PROJECT NAME: Wayne Johnson Community Center Rebuild

SOLICITATION NO: B191051

RE: ADDENDUM #1

ADDENDUM NO. 2

1 LIGHTING PLAN
E-100 1/8" = 1'-0"

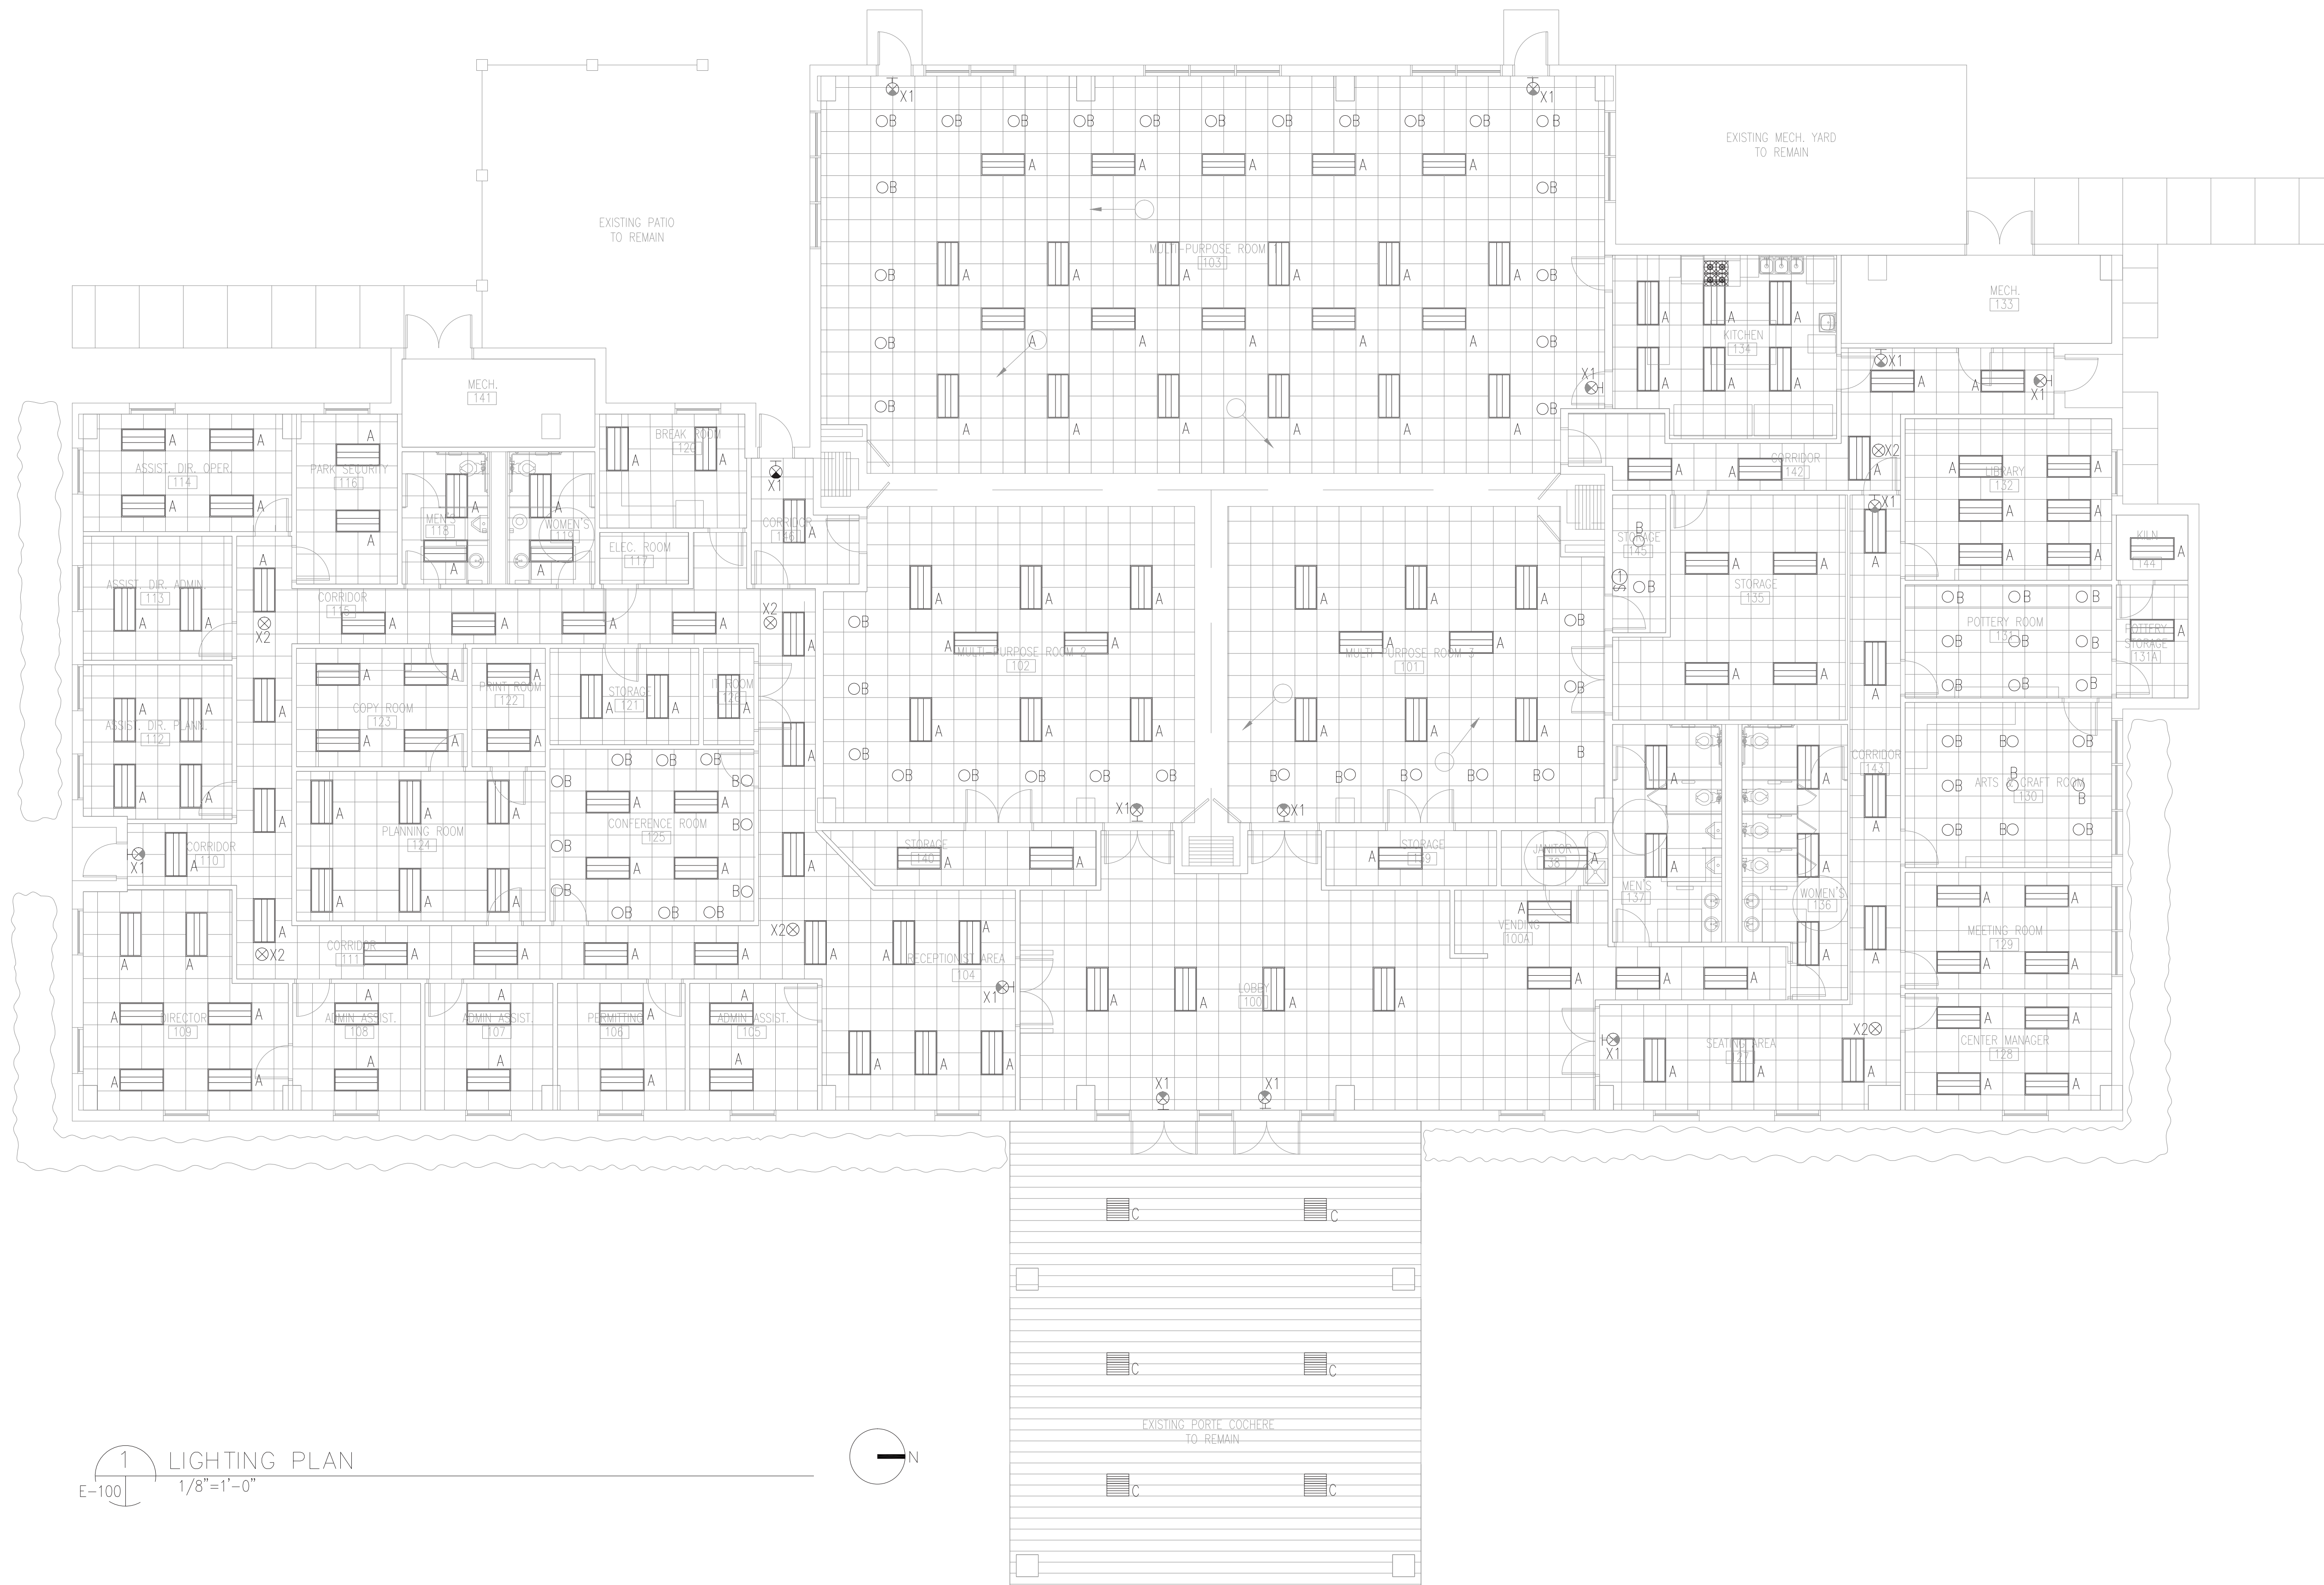
Question #21 *For lighting – is it a requirement to replace the bulbs with LED?*

Response: All new LED light fixtures are to be used. Re: Addendum No. 2 ELECTRICAL drawing.

1. Sheet A-101 Floor Plan Room Improvements

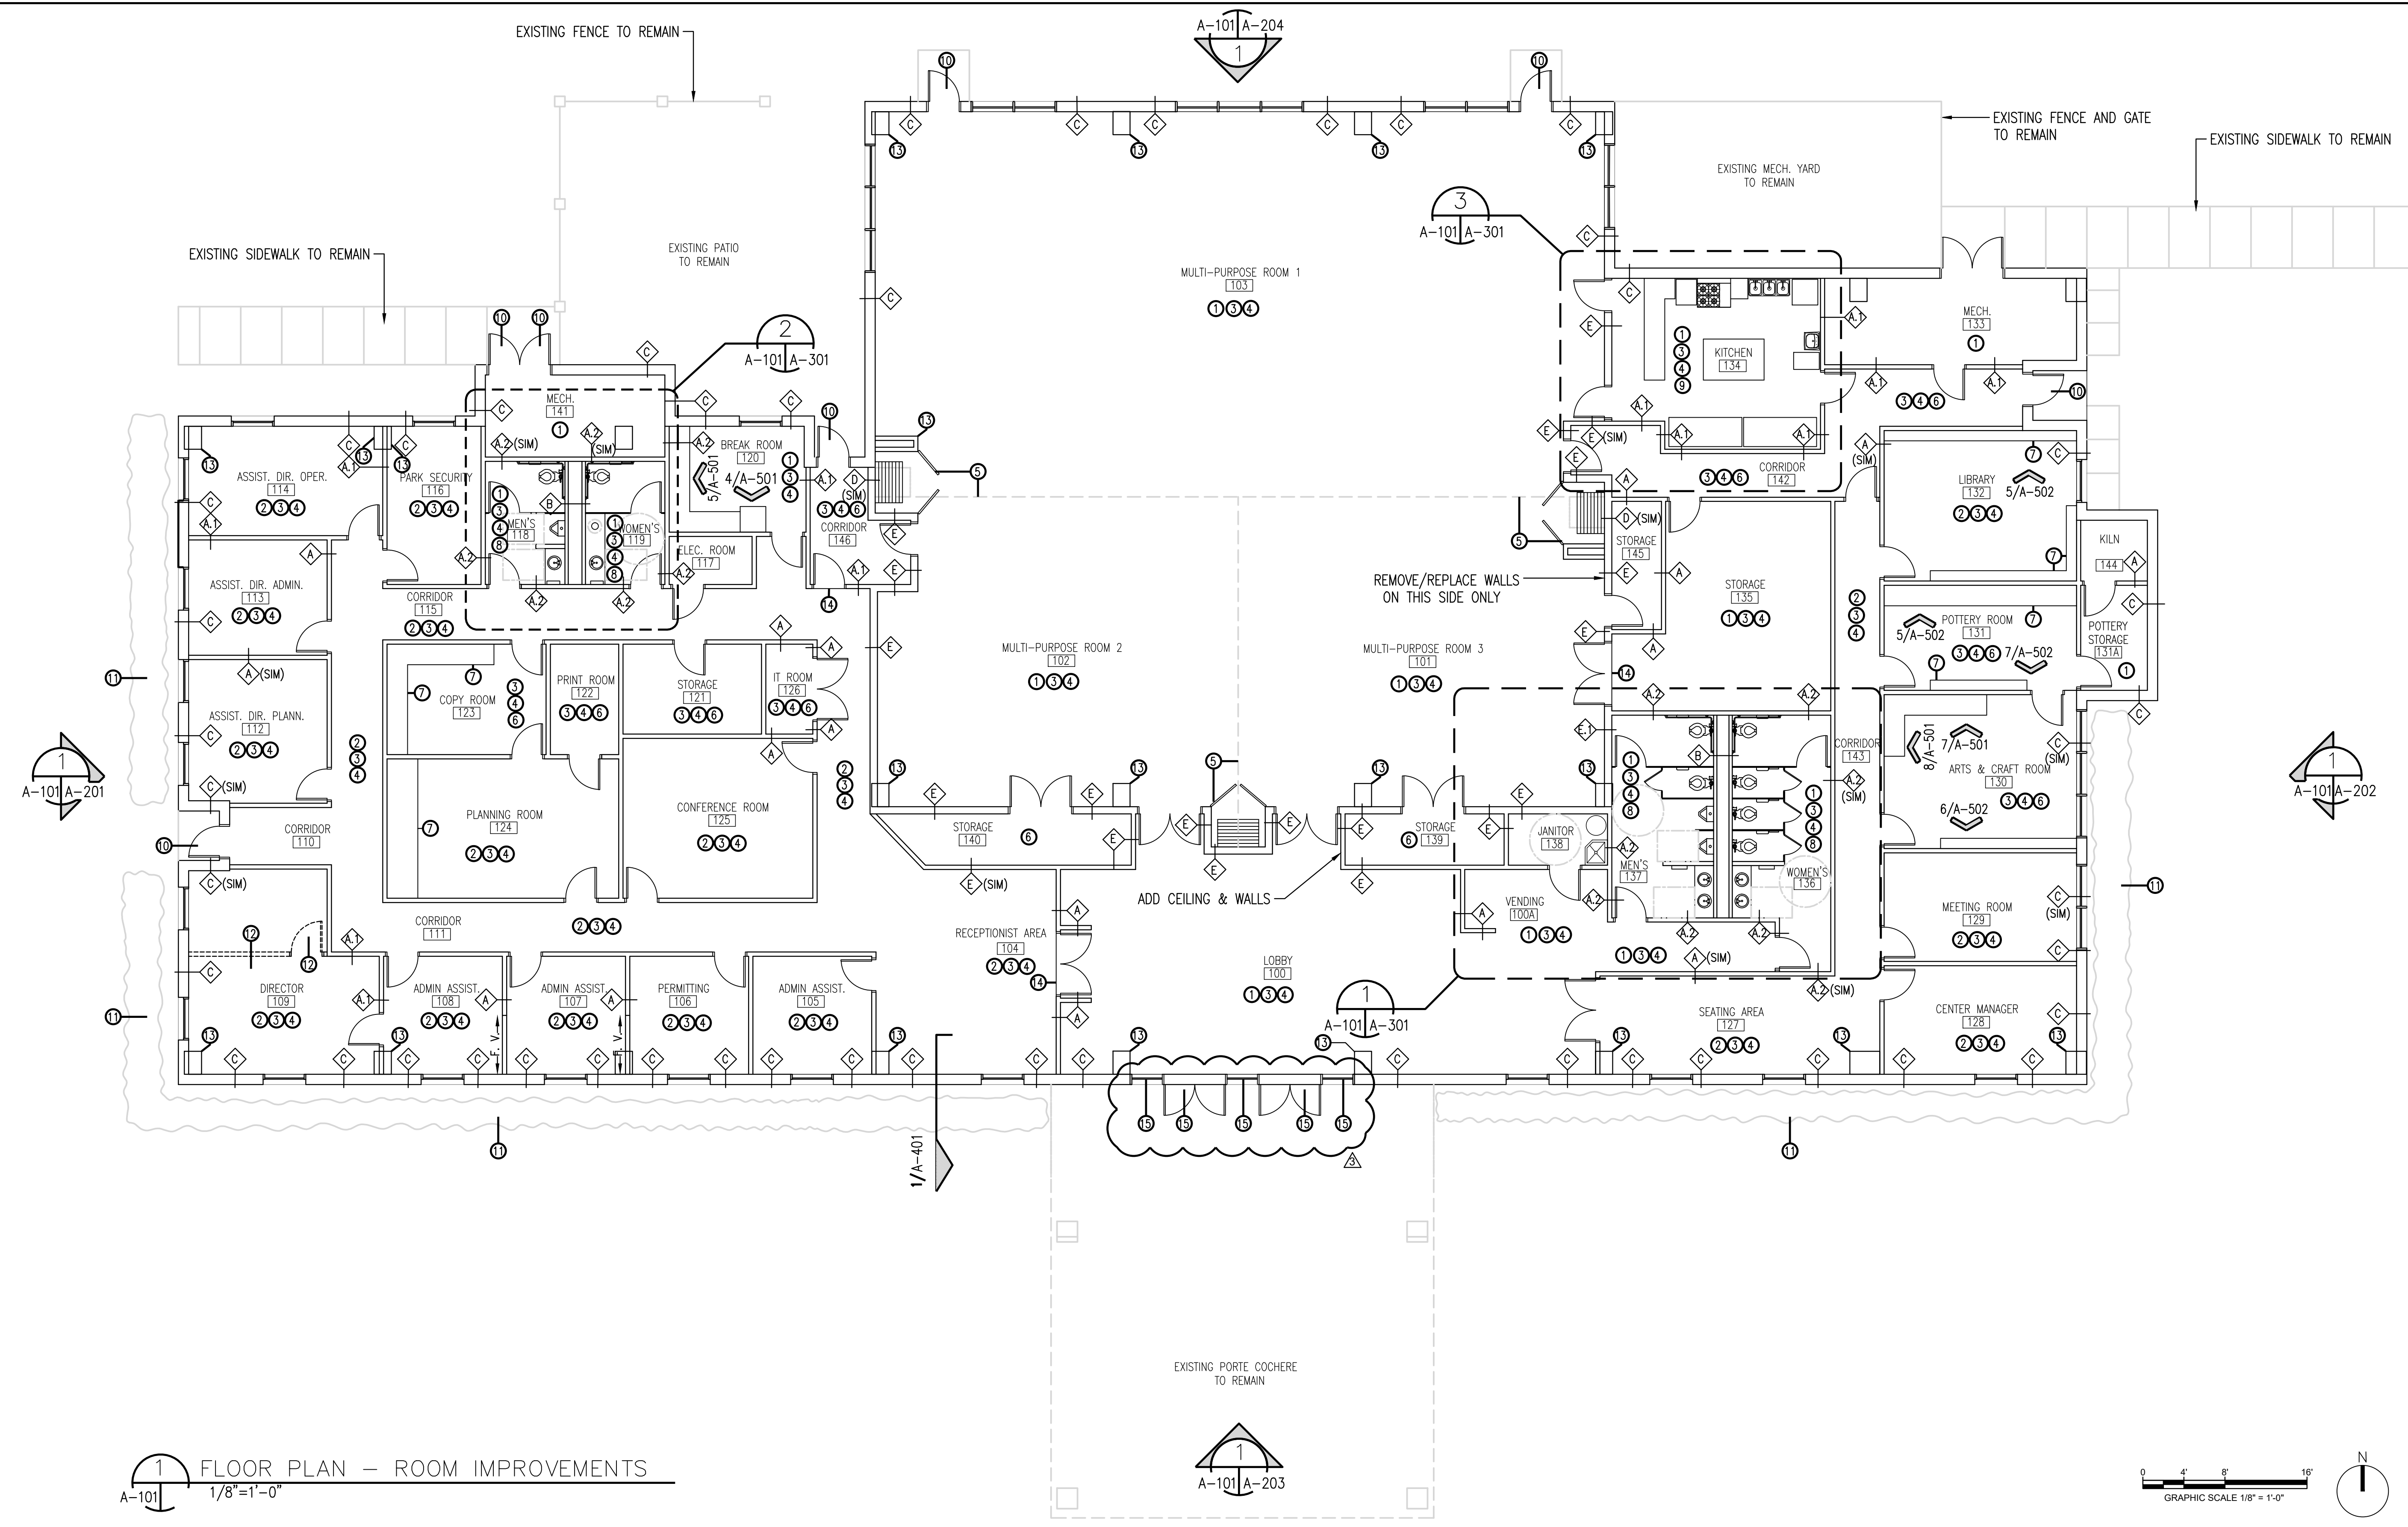
Remove Sheet A-101 Floor Plan Room Improvements and Replace with revised Sheet A-101 Floor Plan Room Improvements attached herein.
